# Access Compliance Report

## Public Rights-of-Way

### (Curb Ramps)

Intersection ID: 5704	Main Street: W_W_T_HARRIS_BV	Cross Street: N_TRYON_ST	Location: W
ADA ID: 4F94B7A2F2B8	Ramp Type: Perp	Initial Pass/Fail: Fail	Overall Compliance: No
		Severity Score: 25

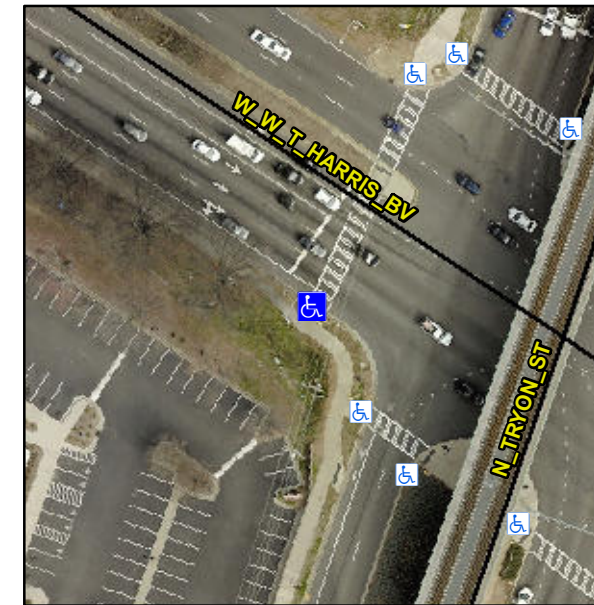
**Not Found, R304.2.2, R304.5.3**

Compliance	Description	Data	Compliance	Description	Data
N/A	Ramp Length (in)	69.0	No	Ramp Slope (%)	8.4
Yes	Ramp Width (in)	96.0	No	Ramp XSlope (%)	5.6
N/A	Flare Type LT	N/A	N/A	Flare Type RT	N/A
N/A	Flare Slope LT (%)	N/A	N/A	Flare Slope RT (%)	N/A
N/A	Flare Traversable LT?	N/A	N/A	Flare Traversable RT?	N/A
N/A	Landing Length (in)	N/A	N/A	DWS Provided?	N/A
N/A	Landing Width (in)	N/A	N/A	DWS Contrast?	N/A
N/A	Landing Slope (%)	N/A	N/A	DWS Length (in)	N/A
N/A	Landing X Slope (%)	N/A	N/A	DWS Full Width?	N/A
N/A	Landing Curb? (Y/N)	N/A	N/A	DWS Offset (in)	N/A
N/A	Shared Landing?	N/A			
N/A	Gutter Ponding?	N/A	N/A	Gutter Slope (%)	N/A
N/A	Gutter Lip Ht (in)	N/A	N/A	Gutter X Slope (%)	N/A
N/A	Painted X Walk1?	No	N/A	Painted X Walk2?	N/A
	X Walk 1 Direction	To NE		X Walk 2 Direction	N/A
N/A	X Walk 1 Width (in)	N/A	N/A	X Walk 2 Width (in)	N/A
	X Walk 1 Slope (%)	0.2		X Walk 2 Slope (%)	N/A
	X Walk 1 X Slope (%)	3.9		X Walk 2 X Slope (%)	N/A

**Remove & Replace Entire Ramp.**
